ADDENDUM No. 1

REQUEST FOR QUOTATIONS No.: 1220-040-2022-020

TITLE: Coverdale Fairgrounds Shannon Hall Boiler Replacement

ADDENDUM ISSUE DATE: February 15, 2022

DRAWING TITLE:
MECHANICAL ROOM PLAN

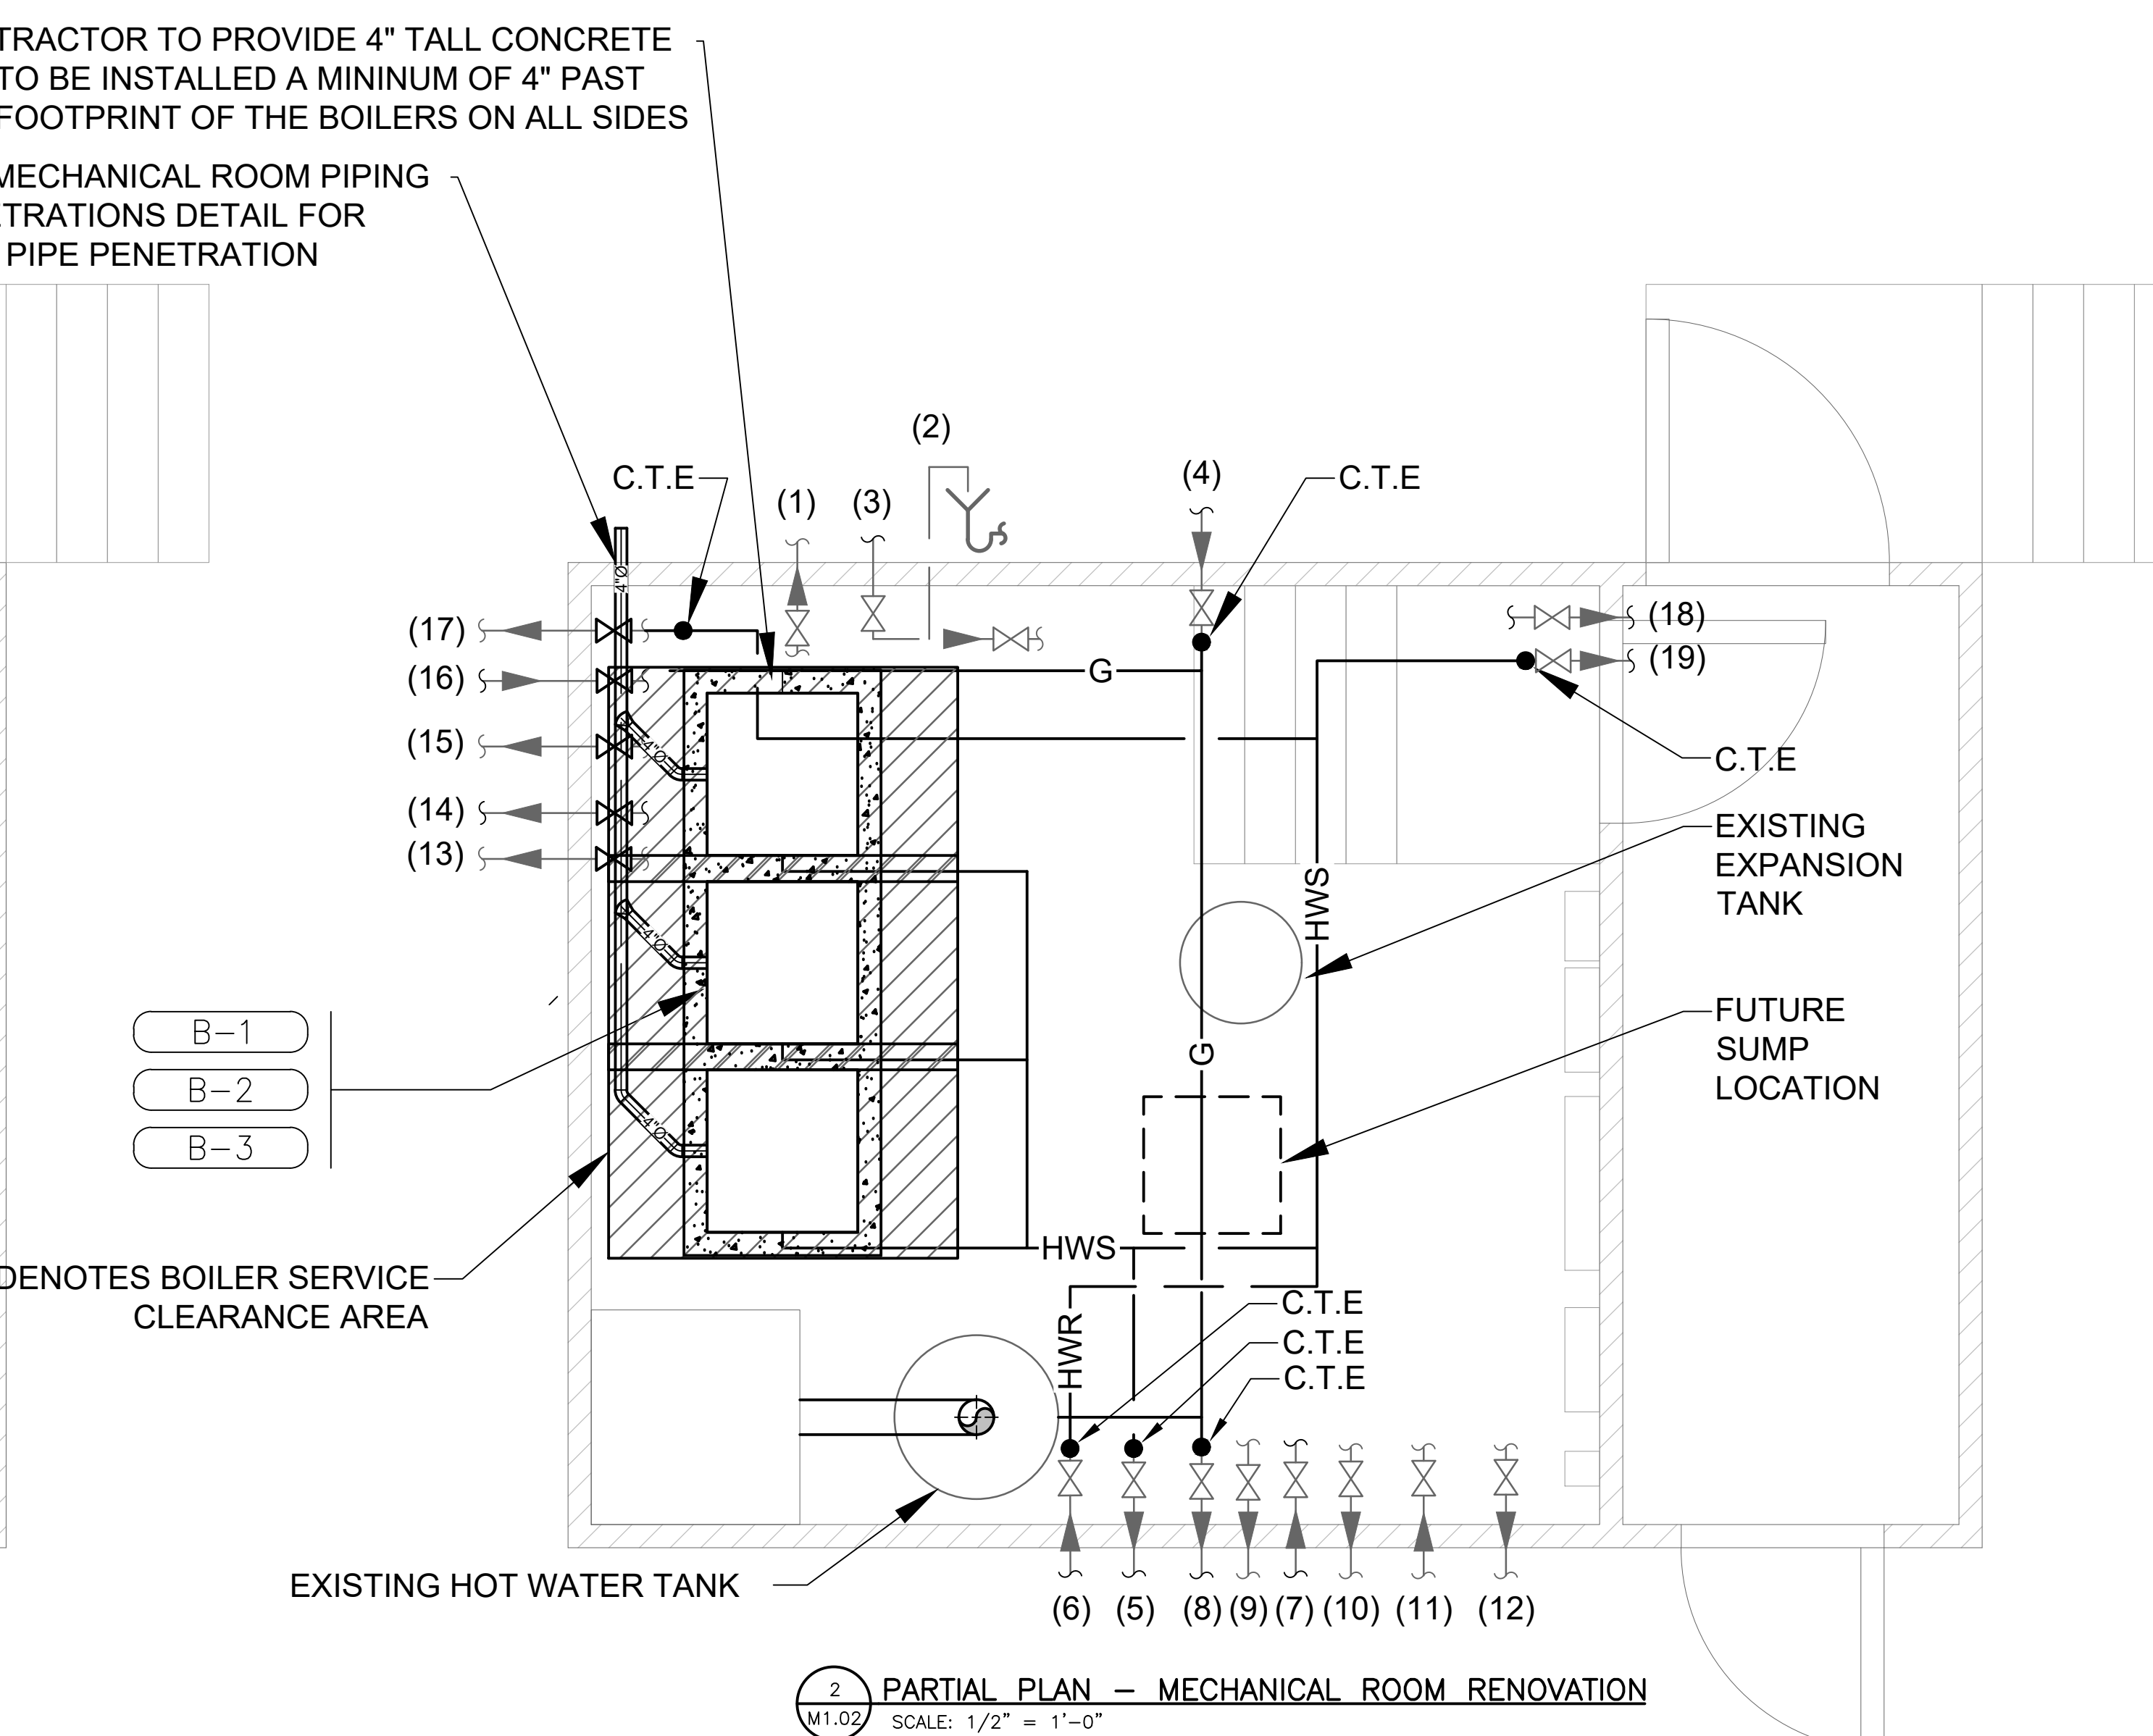
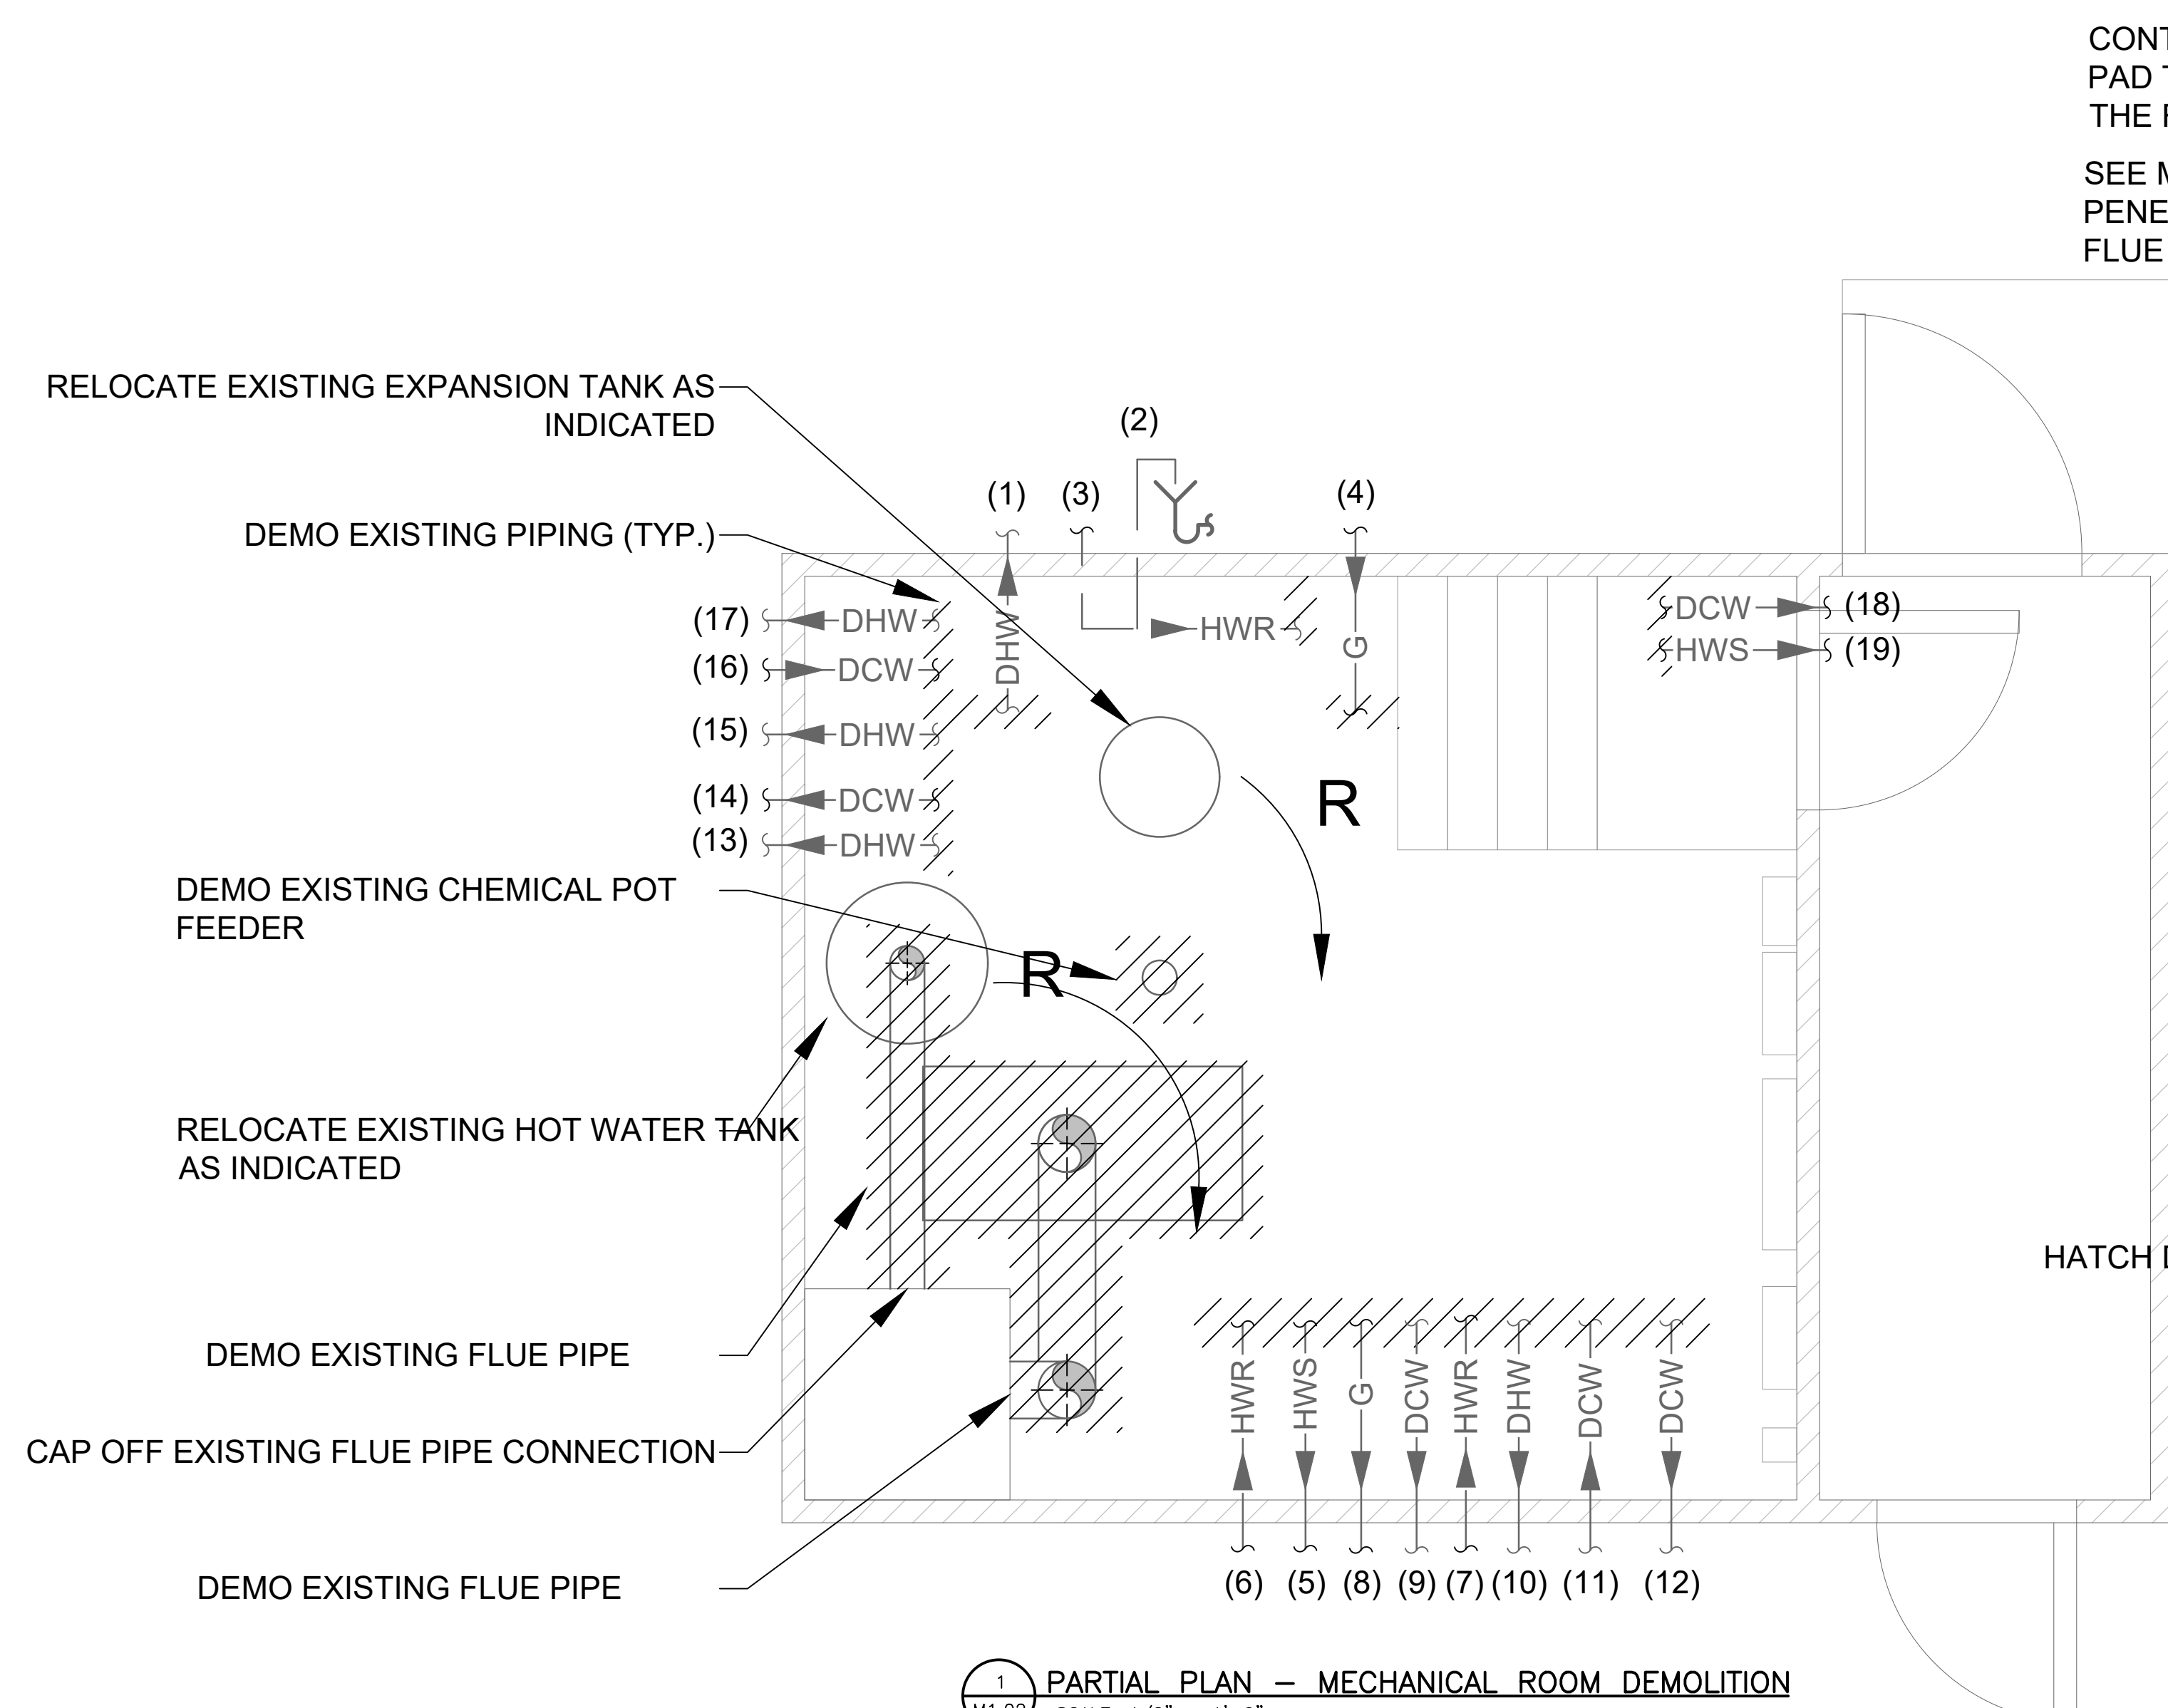
Q7. To avoid dealing with abatement on the proposed lead paint on the walls. Can we terminate the flue through a crafted box to match the exterior walls?

A7. Thank you for the proposed solution, however the flue pipe termination is noted on detail #3 of drawing M1.02 [Mechanical Room Wall Piping Penetrations] as terminating through the window, which to our understanding does not require any abatement.
